IREDELL COUNTY HEALTH DEPARTMENT

IMPROVEMENT PERMIT / CERTIFICATE OF COMPLETION / OPERATION PERMIT / EXISTING SYSTEM INSPECTION

PROPERTY DESCRIPTION NO. 17469 DATE 12-22-93 TAX MAP NO. 8K-10-A-3 Watershed: ☐ Yes ☑ No

SUBDIVISION Warren Estates BLOCK / SECTION — LOT 3 LOT AREA 1.6 acres SITE CLASS. P.S. DESIGN FLOW 360 L.T.A.R. .27 gpd / ft²

AS BUILT SKETCH lines on 11-3-94. Inspected pressure manifold, Alarm, Floats, NEMA 4X Box on 11-29-94

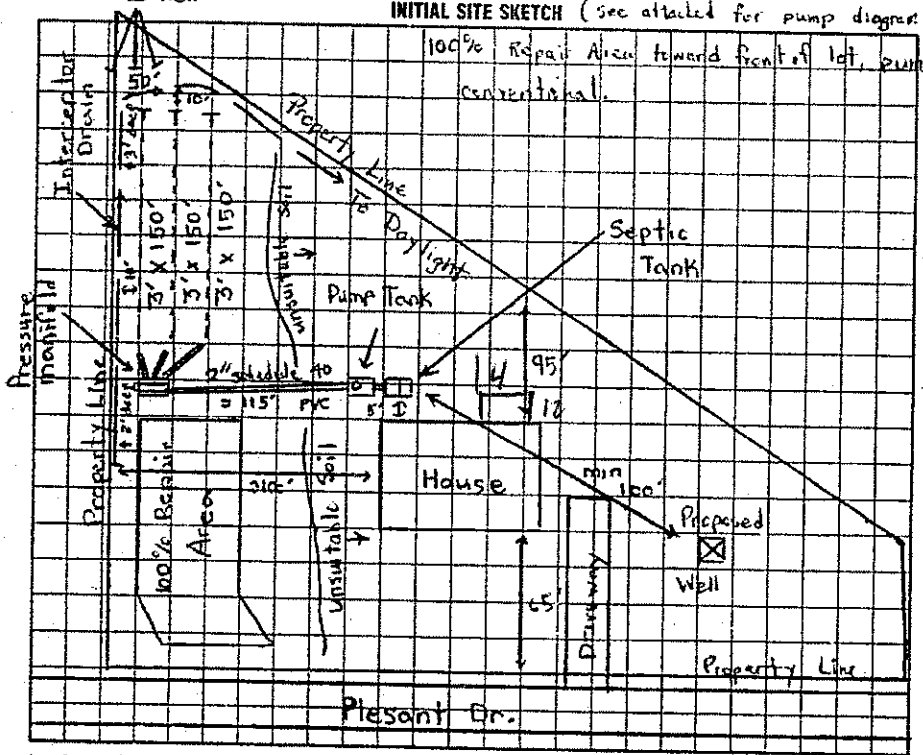
Comments: 1st line of system installed too deep (36" to trench bottom) Pulled pipe and gravel out and filled back in. Draped down stone if need installed system. Caught installer after only first line (36" to trench bottom) was installed. Pushed system down the hill approx 5'. Inspected drain

Inspected interceptor drain on 11-8-94. It was only 2 1/2' deep and part of it was no 10' from drain lines. They will re-do and call back. Re-Inspected Interceptor drain on 11-23-94 JCM

* except system is 5' further down hill, due to improper installation of 1st line.

Comments: Pump to pressure manifold. INSTALL SYSTEM SHALLOW (no deeper than 15" to trench bottom) Keep Nitrification Lines on contour. Install interceptor drain around septic system, min. 3' deep and gravel up to 6" to surface, run to daylight. Install pump that will deliver 36 gpm at 16.0 TDH
